SUBJECT: AMENDMENT NO. 151 TO FACILITY OPERATING LICENSE NO. DPR-49: ATWS  
MODIFICATIONS TO COMPLY WITH 10 CFR 50.62 (TAC NO. 64789)

Amendment No. 151  
License No. DPR-49

SAFETY EVALUATION BY THE OFFICE OF NUCLEAR REACTOR REGULATION  
RELATED TO AMENDMENT NO. 151 TO FACILITY OPERATING LICENSE NO. DPR-49

Minimum Temperature of  
 Sodium Pentaborate Solution  
 FIGURE 3.4-2

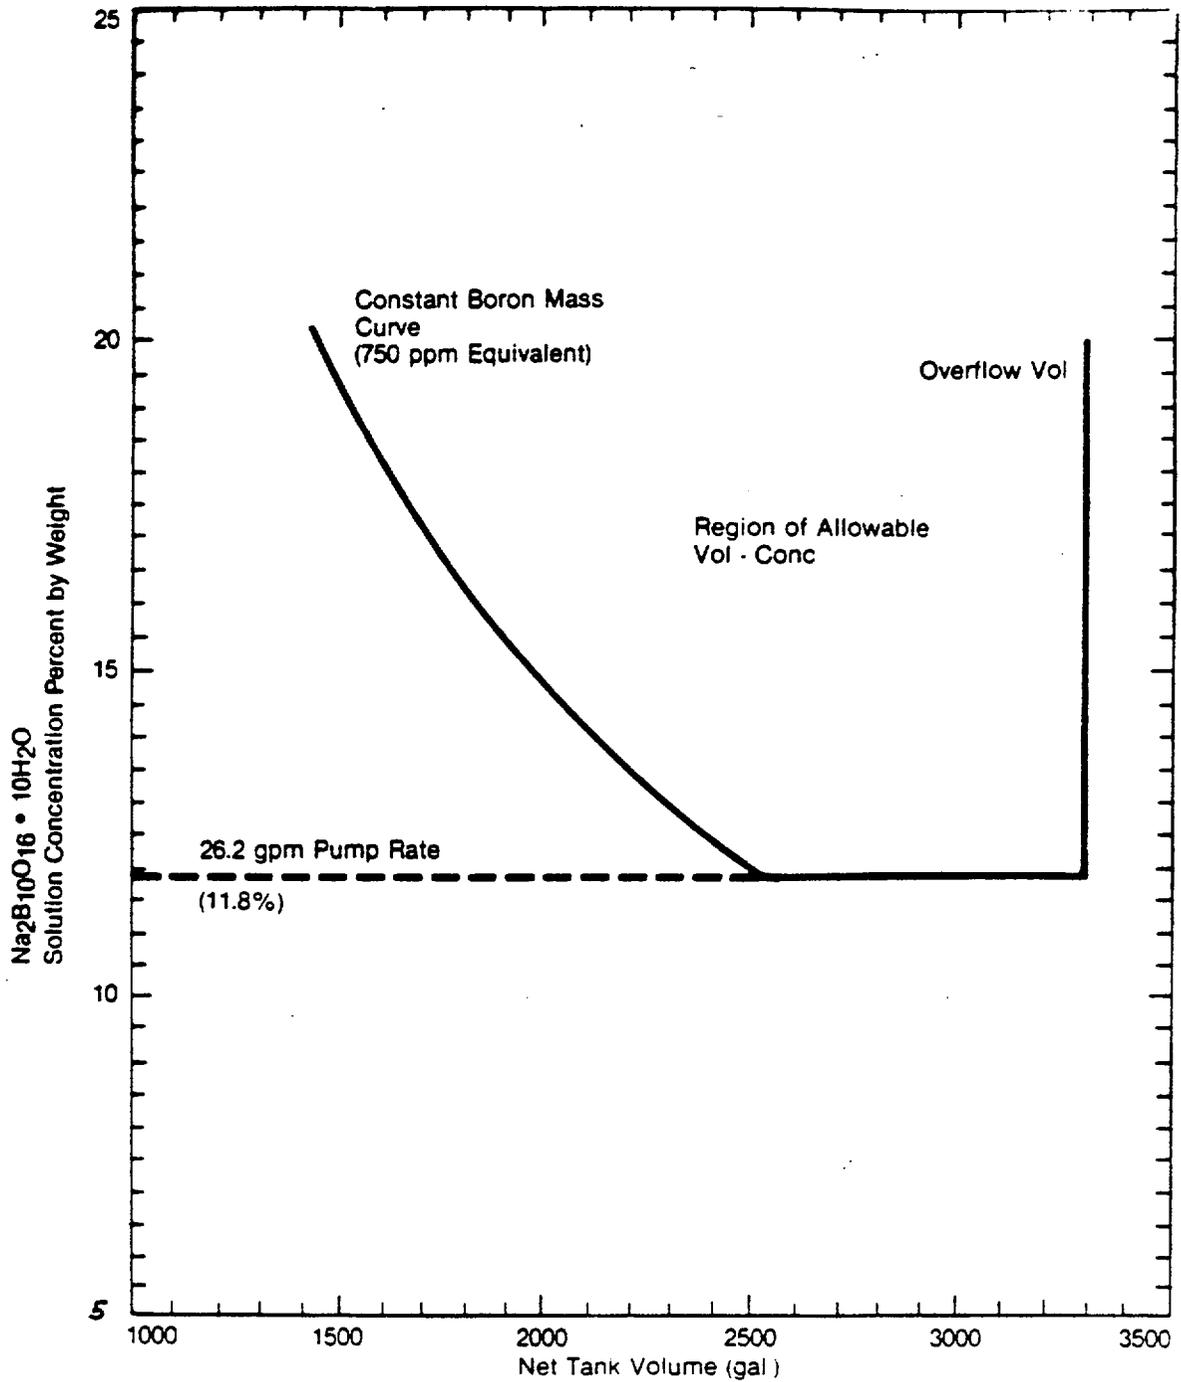
The solution is kept at least 5°F above the saturation temperature to guard against boron precipitation. The margin is included in Figure 3.4-2.

The changed values lead to proposed Technical Specification changes. These include doubling the pump flow rate from 26.2 gpm for single pump operation to 52.4 gpm for dual pump operation in TS 3.4.1 and changing Figure 3.4-1 for the SLC solution concentration versus tank volume curve. The changes are necessary to reflect the new concentration limits which will ensure that the plant meets both the new ATWS requirements and the original SLC design requirements. The SLC design requirements are met using one pump based on the minimum flow rate of 26.2 gpm for one-pump operation. Also, Figure 3.4-2 is added to incorporate the

minimum solution temperature curve generated by adding 5°F margin instead of 10°F margin to the actual saturation temperature curve as described in the Basis 3.4.3. This is consistent with Final Safety Analysis Report Section 9.3.4.3 and acceptable. The licensee indicated that the Union Pump Co. (UPC) has tested and certified that net positive suction head requirements are satisfied and that vibration readings were well within acceptable levels for two-pump operation (Ref. 7). The associated Basis 3.4 has also been changed to reflect the revised approach and requirements. The staff finds that the licensee's approach meets the requirements of 10 CFR 50.62, paragraph (c)(4), and is, therefore, acceptable.

Sodium Pentaborate Solution Volume  
Concentration Requirements  
FIGURE 3.4-1

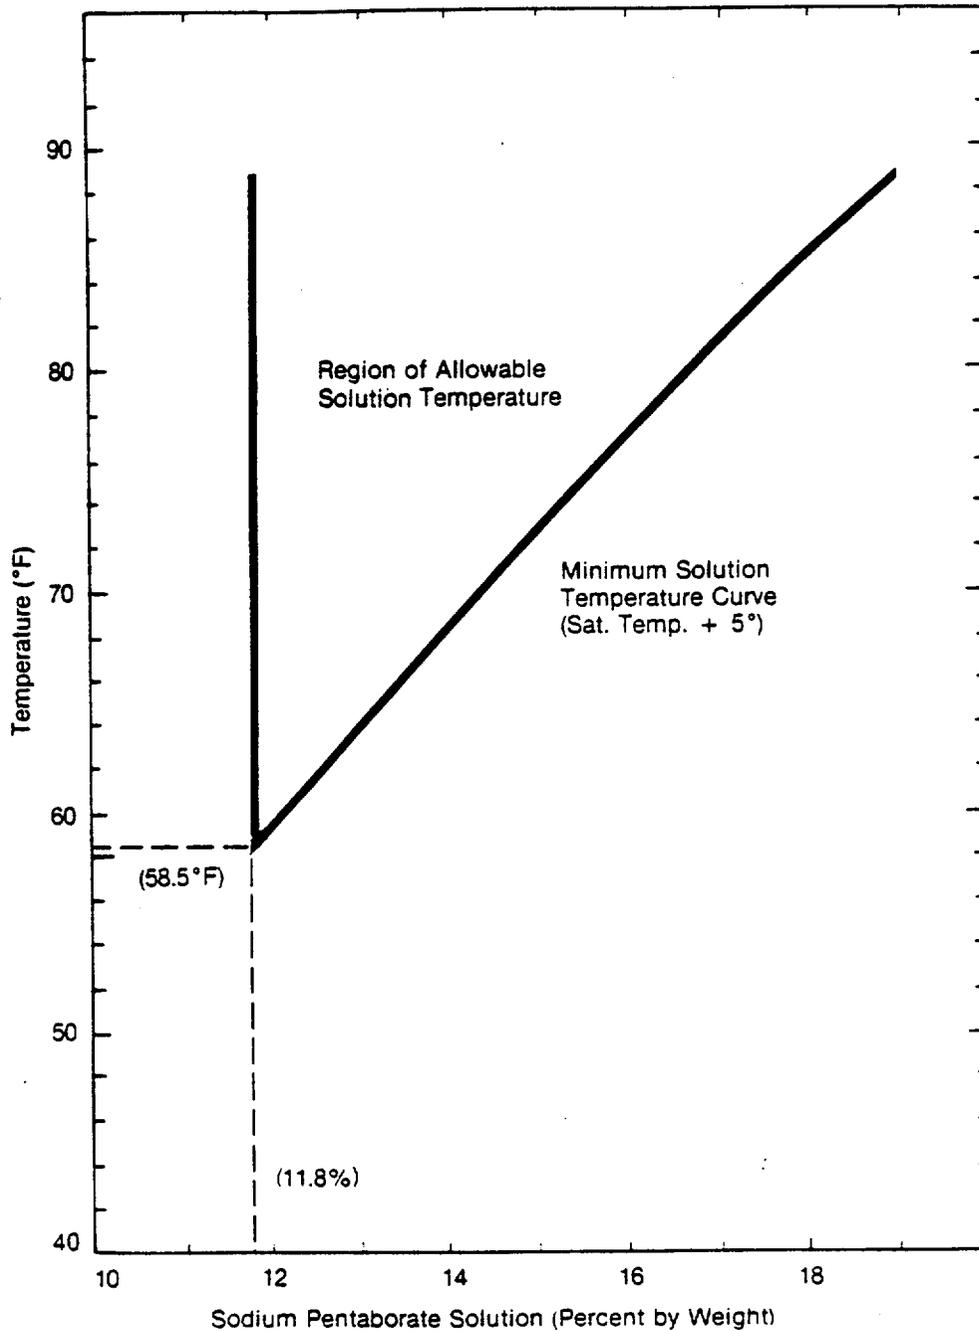
A minimum quantity of 2500 gallons of solution having a 11.8 percent sodium pentaborate concentration, or the equivalent as shown in Figure 3.4-1, will ensure that both the SLCS design basis (11.8%) and ATWS (11.2%) shutdown requirements are met. The maximum net storage volume of the boron solution, as established by the overflow, is 3270 gallons.
